CITY PLAN COMMISSION

FILE NUMBER: PLAT-25-000012 (S245-181)

LOCATION: Dowdy Ferry Road, south of Plainview Drive

REQUEST: An application to create one 29.995-acre lot from a tract of land in City Block 8524 on property located on Dowdy Ferry Road, south of Plainview Drive.

THE PURPOSE OF THIS PRELIMINARY PLAT IS TO CREATE 1 LOT FROM A 29,995 ACRE TRACT OF LAND DOWDY FERRY LOT 1 BLOCK 8524

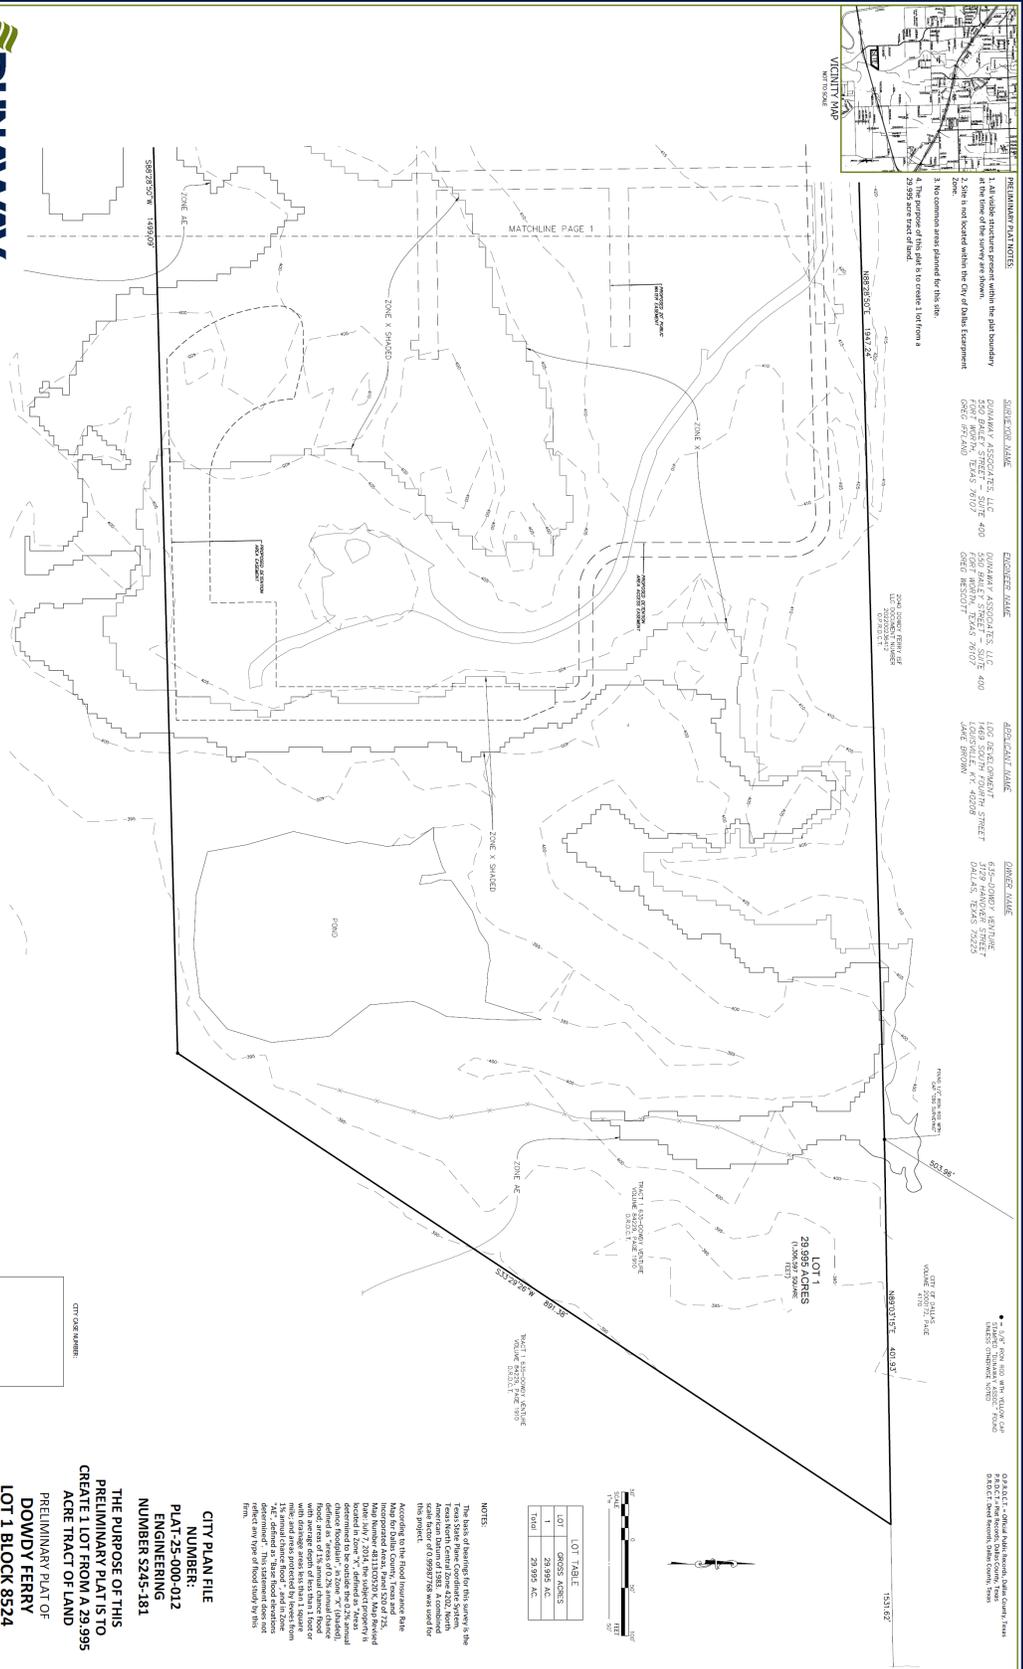
STAFF RECOMMENDATION: The request complies with the requirements of the MU-1 Mixed Use District 1; therefore, staff recommends approval of the request subject to compliance with the following conditions:

16. On the final plat, determine the 100-year water surface elevation across this addition.
17. On the final plat, dedicate floodway easement, floodway management area or floodway easement (within common area), with the appropriate easement statement included on the face of the Plat. 51A 8.611(d); DWU Floodplain Management; Drainage Design Manual Addendum V
18. On the final plat, include additional paragraph in Owner's Certificate (pertaining to the floodplain). 51A 8.611(d); DWU Floodplain Management; Drainage Design Manual Addendum V
19. On the final plat, specify minimum fill and minimum finished floor elevations. *Section 51A-8.611(d), Trinity Watershed Management.*
20. On the final plat, show the natural channel set back from the crest of the natural channel. *Section 51A-8.611(d), Trinity Watershed Management.*

21. Prior to submission of the final plat, set floodway monument markers and provide documentation that the monuments have been set. *Section 51A-8.617(d)(1), (2), (3), and (4)*
22. Provide information regarding Fill Permit or Floodplain Alteration Permit if such permit is applied for.

23. Prior to final plat, submit a completed final plat checklist and all supporting documents.
24. On the final plat, show how all adjoining right-of-way was created. Section 51A-8.403(a)(1)(A)(xxii).
25. On the final plat, show recording information on all existing easements within 150 feet of the property.
26. On the final plat, chose a new or different plat name.

27. Additional design information is required for assessment. Site plan must be submitted showing proposed development, building finished floor elevation, development, existing mains – including downstream manhole, and proposed water and wastewater service locations. Submit water/wastewater engineering plans to 320 E. Jefferson Blvd., Room 200, Attention: Water and Wastewater Engineering.
28. Water and Wastewater main improvements is required by Private Development Contract. Submit water/wastewater engineering plans to 320 E. Jefferson Blvd., Room 200, Attention: Water and Wastewater Engineering.
29. Existing and any proposed Water and Wastewater Easements must be shown and/or increased to conform to current design standards. **Notice:** Minimum DWU easement size 20' for one utility and 25' for both water and sewer. Larger diameter or deeper mains may require additional width.

30. Prior to final plat, additional design information is required for assessment. Site plan must be submitted showing proposed development, including any new public roads proposed within the property.
31. On the final plat, identify the property as Lot 1 in City Block B/8524.
